Addendum 47 – UN Regulation No. 48

Revision 12 - Amendment 8

Supplement 12 to 06 series of amendments – Date of entry into force: 15 October 2019

Installation of lighting and light-signalling devices

"Part 5 – Example of illuminating surface in comparison with light-emitting surface in the case of a "single function lamp" (see paragraphs 2.10.2. to 2.10.3. of this Regulation)

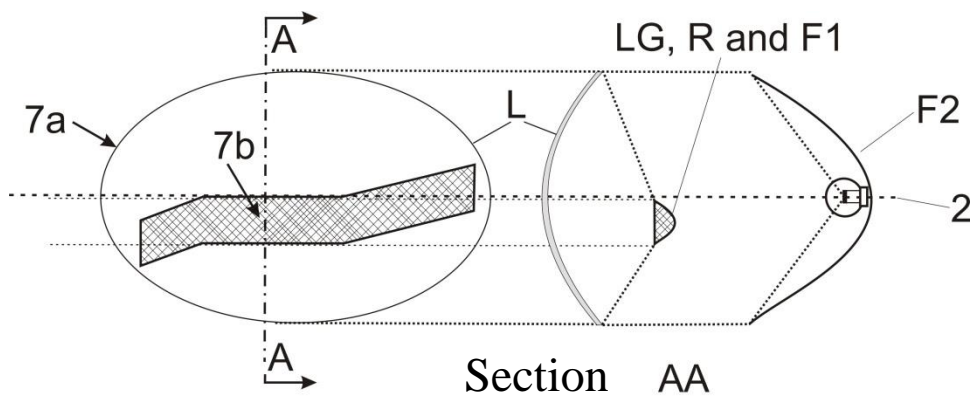
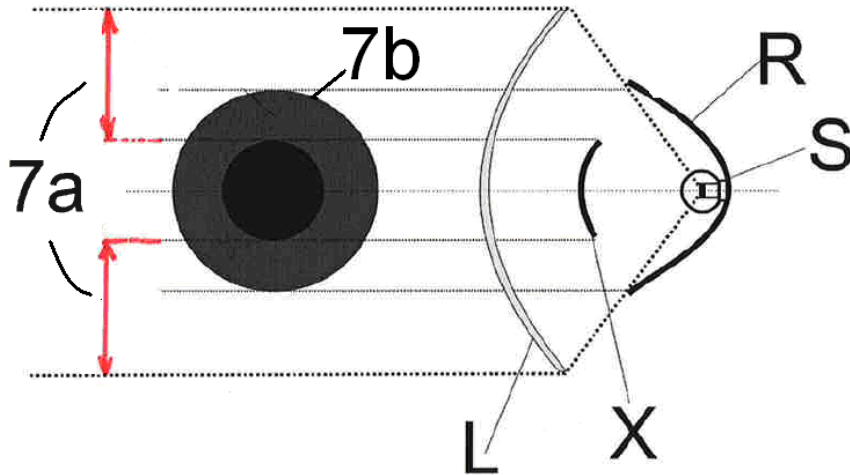
Part 5, amend to read:

In the case where the non-textured outer lens is excluded, "7b" is the apparent surface according to paragraph 2.10.2. (b).

In the case where the non textured outer lens is excluded, "7b" is the apparent surface according to paragraph 2.10.2. (b), and F1 shall not transparent to F2

In the case where the non textured outer lens is excluded, "7b" is the apparent surface according to paragraph 2.10.2. (b).

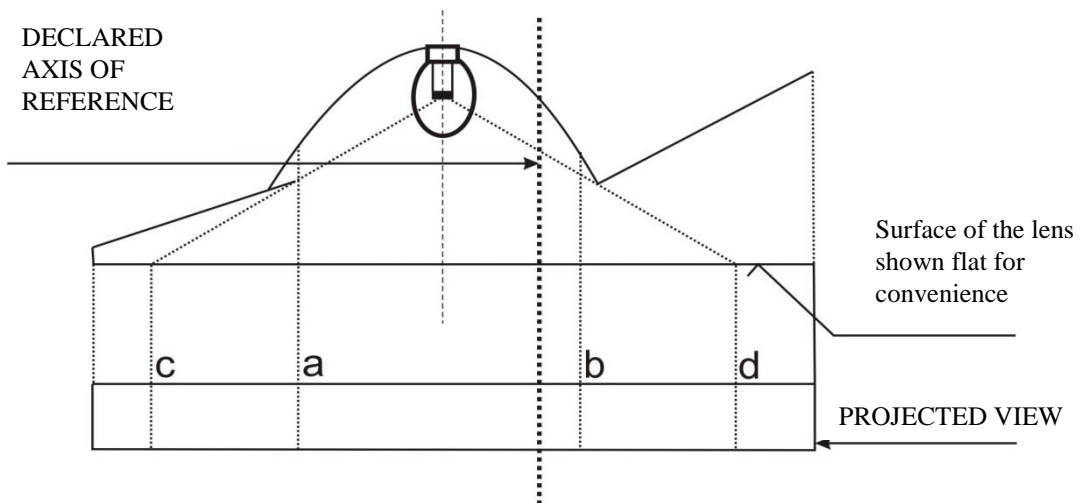
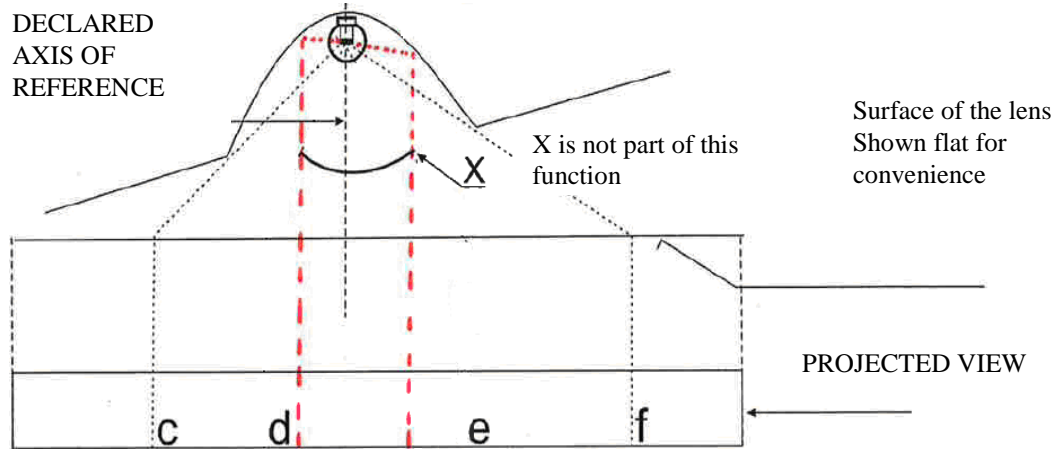
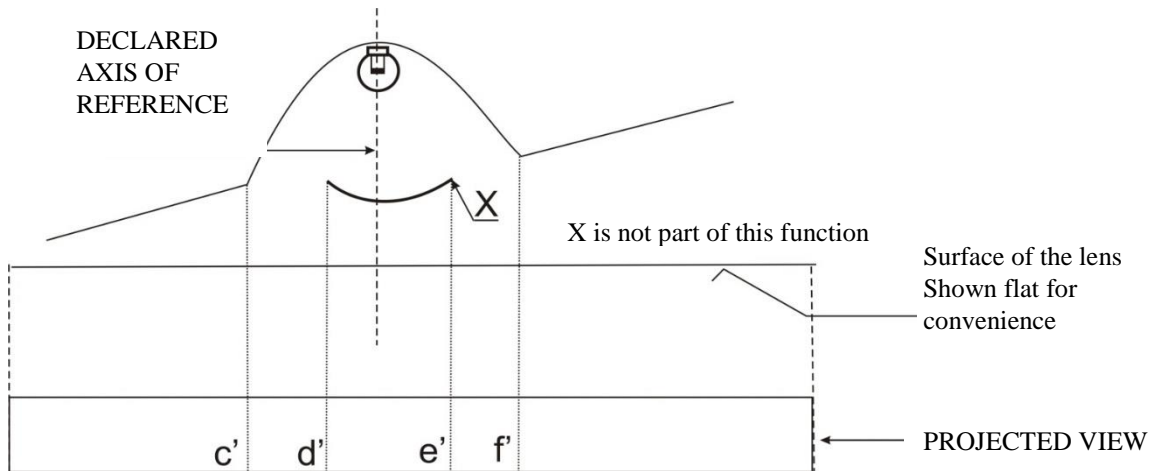
Part 6, amend to read:

<i>Illuminating surface</i>	<i>Declared light-emitting surface according to 2.10.2. (a)</i>
Edges are	a and b	c and d

<i>Declared Light-emitting surface according to 2.10.2. (a)</i>
Edges are	c-d and e-f

<i>Declared Light emitting surface according to 2.10.2. (b) for example</i>
Edges are	c'-d' and e'-f'

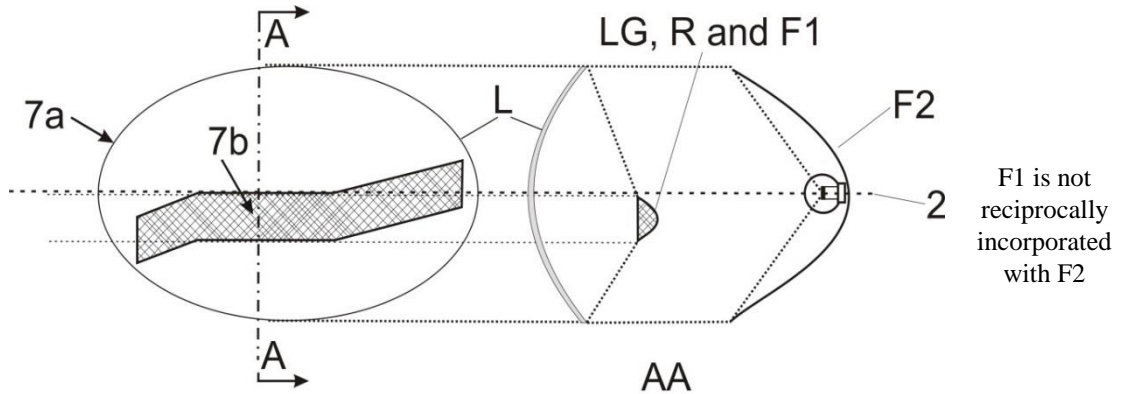
Part 7, amend to read:

In the case where the non-textured outer lens is excluded, "7b" is the apparent surface according to paragraph 2.10.2. and F1 shall not be transparent to F2:
